ADDENDUM No.

²roject Address: RELOCATION of 1-36' \times 40', 1-24' \times 40' Portable classroom bldg. at grovecenter e.s.

DSA FILE NO.: 19-25 DSA A# 03-118460 Owner:
COVINA-VALLEY UNIFIED SCHOOL DISTRICT
519 E BADILLO ST., COVINA, CA

REFLECTED CEILING PLAN Checked: Scale: AS SHOWN Checked: Plot Date: 10.23.2017 Drawing No. F**ilename**:c-vusd grovecen Sheet No.1 of 6

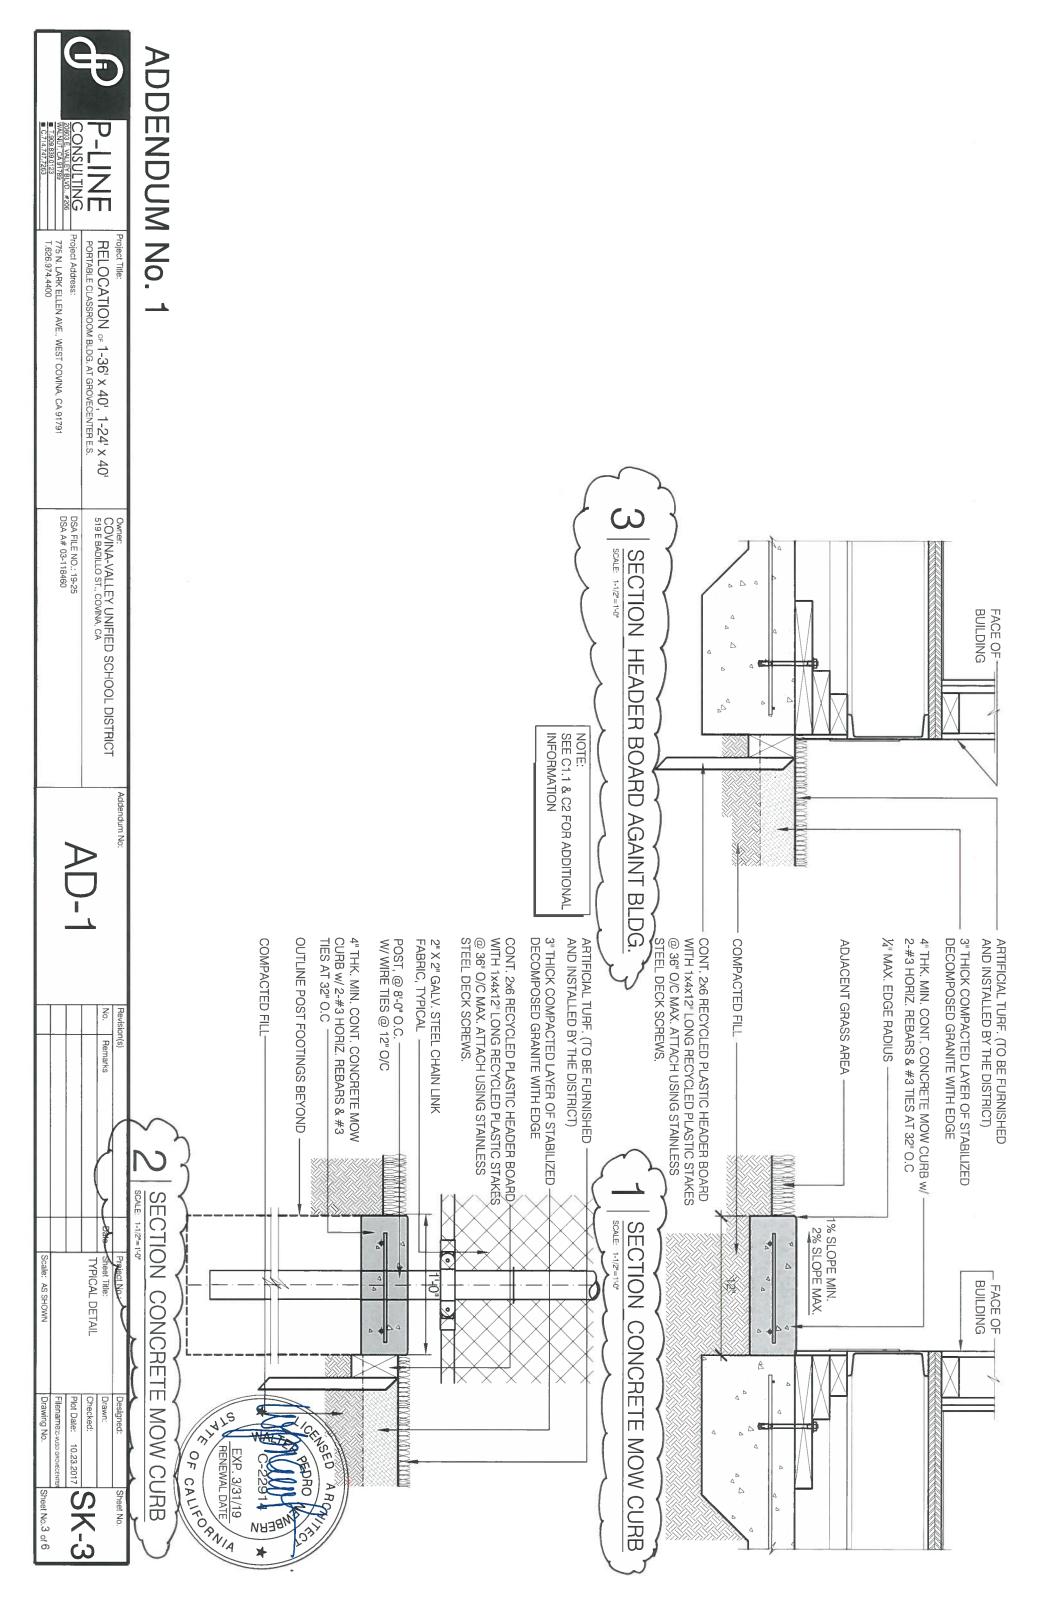
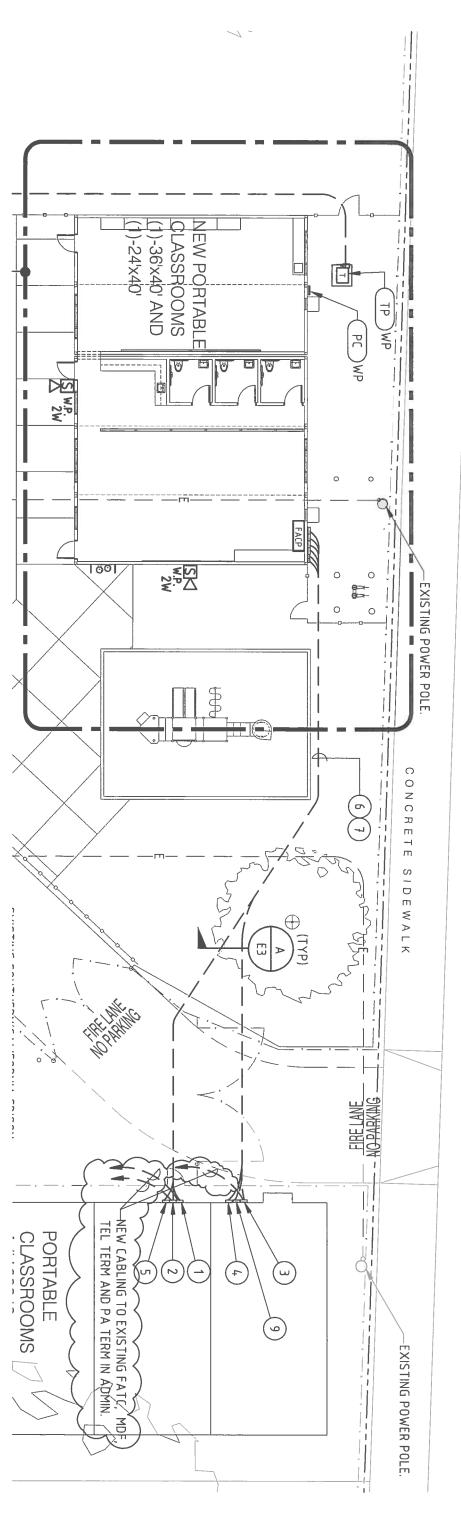
>□ LCD PROJECTOR/SCREEN SEE DET.2/SK-1

No.	Revision(s)
		Remarks	on(s)
		Date	
SITE PLAN AND	PARTIAL ELECTRICAL	Sheet Title:	Project No.:
Plot Date: 10.23.2017	Checked:	Drawn:	Designed:
- NO -	コロロト		Sheet No.
	TES	TES.	Remarks Date PARTIAL ELECTRICAL SITE PLAN AND REFERENCE NOTES

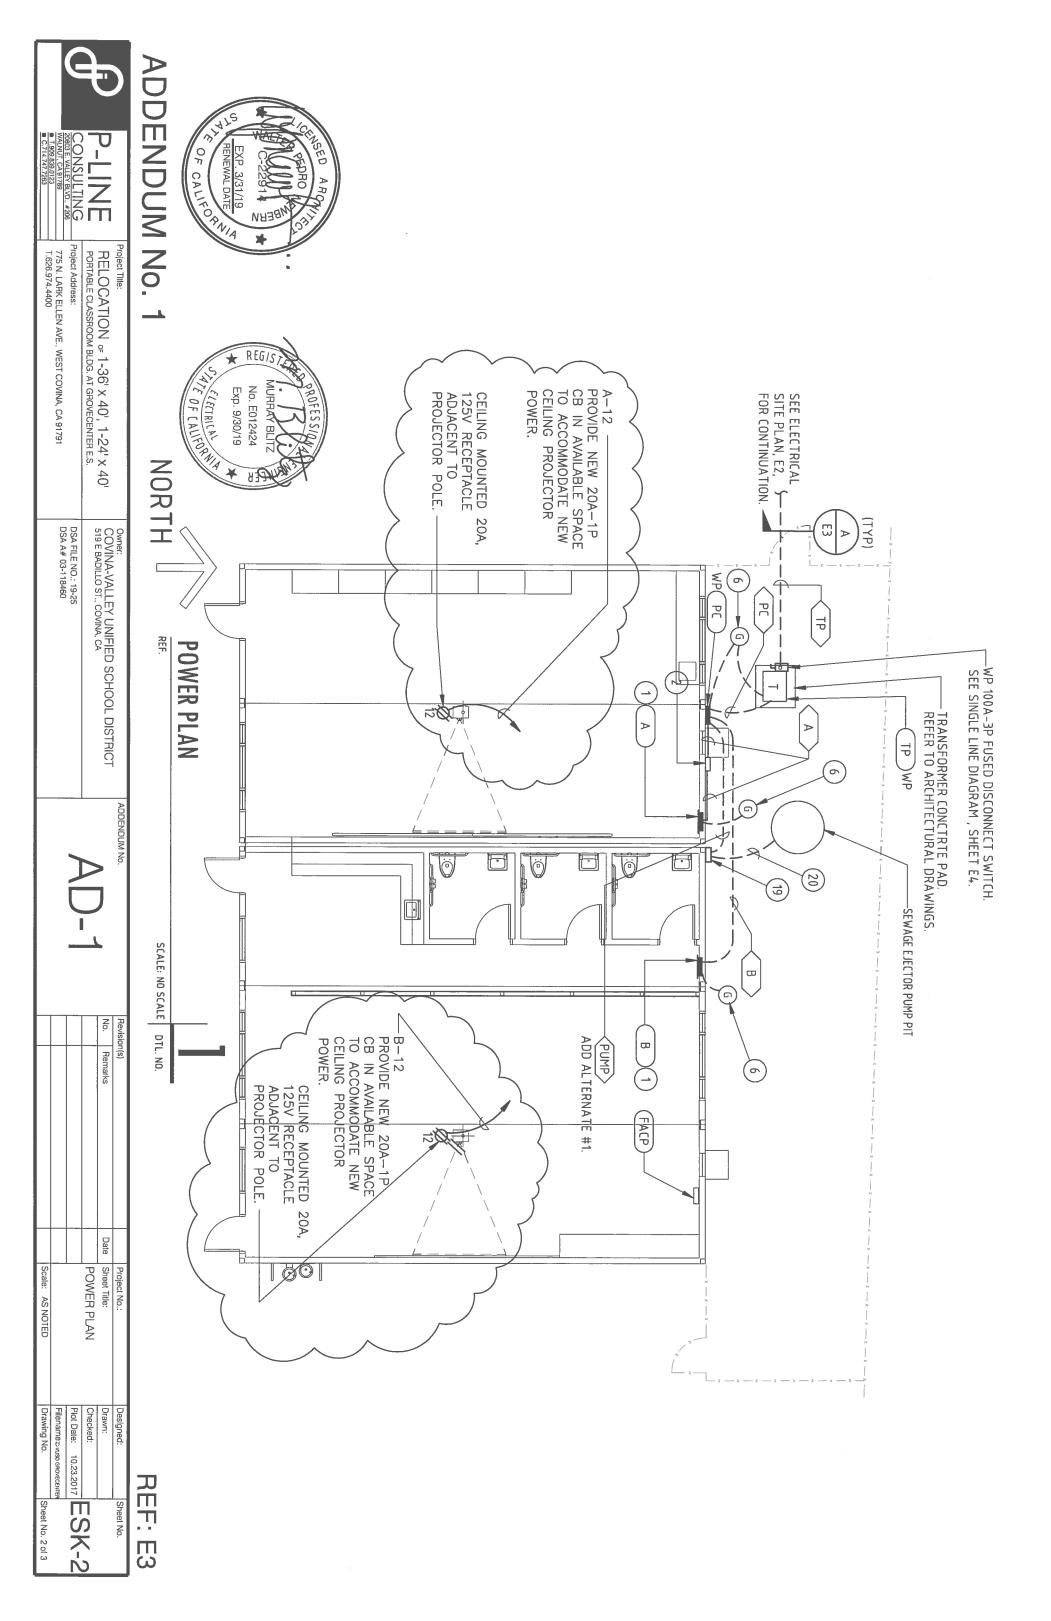
- EXISTING BUILDING MOUNTED CLOCK PULL BOX.
- JOSIGNAL BOXES ON PORTABLE BULLDING EAST OF FIRE LANE: (1) 2"C. 6-STRAND, SINGLE MODE, UNDERGROUND RATED FIBER OPTIC CABLE TO MATCH EXISTING ON CAMPUS FROM IDF TO MDF IN LIBRARY MEDIA CENTER BLDG VIA ADMIN BLDG (APPROX 960'). PROVIDE LC CONNECTORS MATCHING THE EXISTING IN THE LMC MDF. + (4)TEL UG RATED CABLES TO ADMIN (TELEPHONE).
- C. (2) 3PAIR SPEAKER/COMM CABLES TO M TCH EXISTING TO ADMIN (PA/COMM)
- C. WEST PENN AG3245 TO ADMIN FATC FOR FUTURE CAMPUS INTERFACE (FA) BOVE CABLES SHÂLL MATCH EXISTING ON FIBER CABLE PA/COMM CABLES FA AND BUILDING THROUGH EXISTING RACEWAYS.

BUILDING AND LMC BUILDING PRIOR TO CON CAMPUS VERIFY TYPES WITH DISTRICT TEL CABLES FROM EAST PORTABLE TO FIELD VERIFY PATHWAYS TO MMENCING WORK.
- SAW CUT AND TRENCH TO ACCOMMODATE NEW UNDERGROUND CONDUITS.
- FURNISH AND INSTALL PRECAST CONCRETE PULL BOX 17"X30"X24" DEEP WITH STEEL BOLT-DOWN TRAFFIC COVER MARKED "POWER". INSTALL ON 12" OF CRUSHED ROCK. BROOKS PRODUCTS #66-PB BODY, 66-12" EXTENSION AND 66-PB STEEL
- EXISTING BUILDING MOUNTED SPARE PULL BOX

SIGNAL PLAN AND REFERENCE NOTES Filename:c-vuso geovecev Plot Date: Checked: 10.23.2017 ESK-3

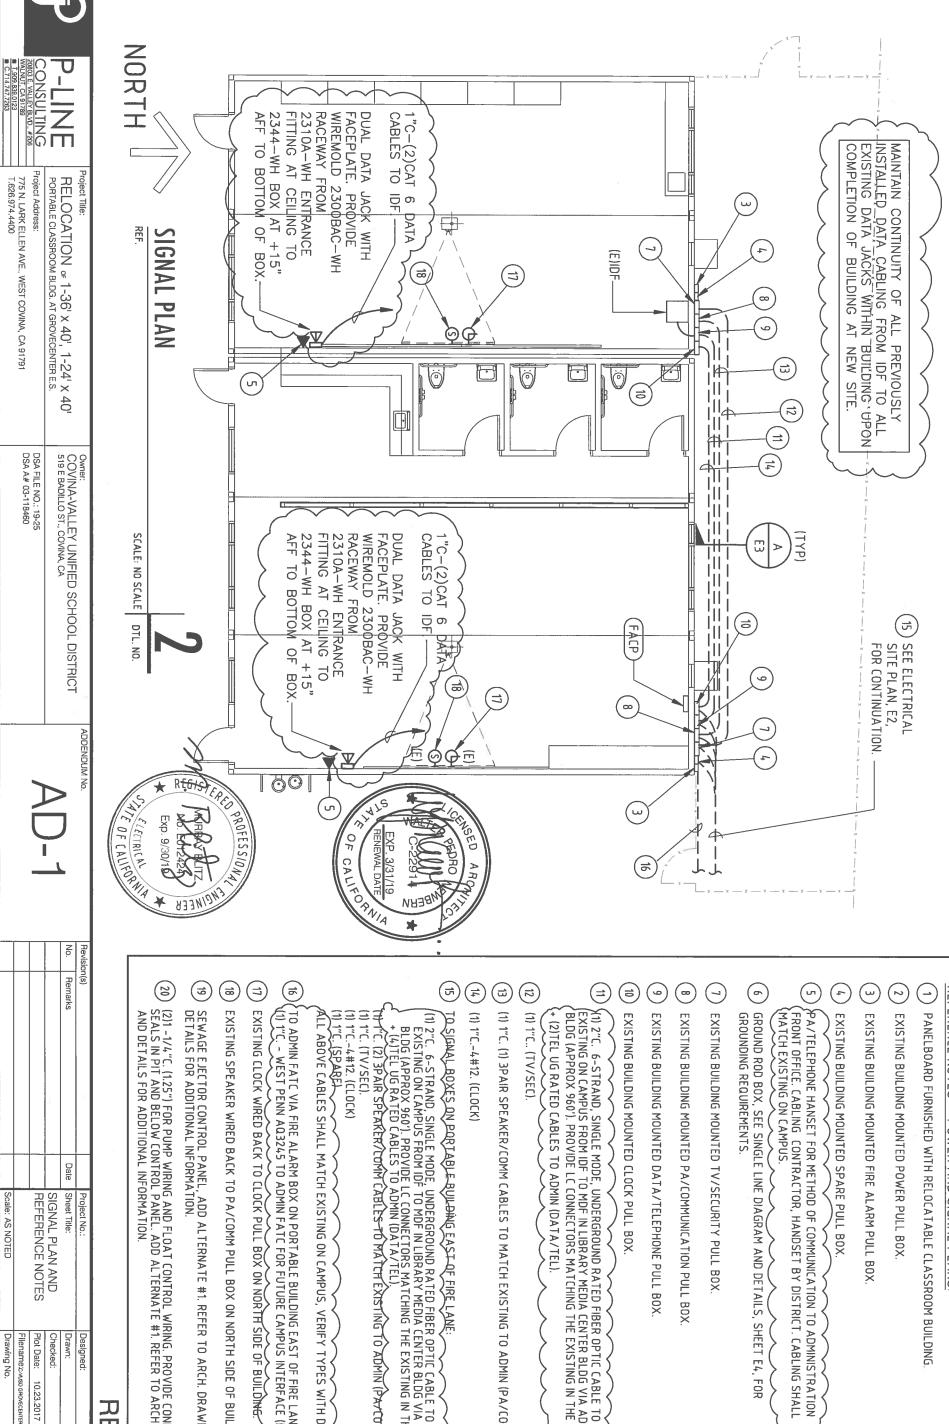
- EXISTING BUILDING MOUNTED CLOCK PULL BOX
- \(\)(1) 2"C. 6-STRAND, SINGLE MODE, UNDERGROUND RATED FIBER OPTIC CABLE TO MATCH\)\\(\)(EXISTING ON CAMPUS FROM IDF TO MDF IN LIBRARY MEDIA CENTER BLDG VIA ADMIN\)\(\)(BLDG (APPROX 960'). PROVIDE LC CONNECTORS MATCHING THE EXISTING IN THE LMC MDF. (2) TEL UG RATED CABLES TO ADMIN (DATA/TEL).

- TO ADMIN FATC VIA FIRE ALARM BOX ON PORTABLE BUILDING EAST OF FIRE LANE:

(1) 1"C. WEST PENN AQ3245 TO ADMIN FATC FOR FUTURE CAMPUS INTERFACE (FIRE ALARM)
- EXISTING SPEAKER WIRED BACK TO PA/COMM PULL BOX ON NORTH SIDE OF BUILDING
- TROL PANEL, ADD ALTERNATE #1. REFER TO ARCH. DRAWINGS AND VAL INFORMATION.
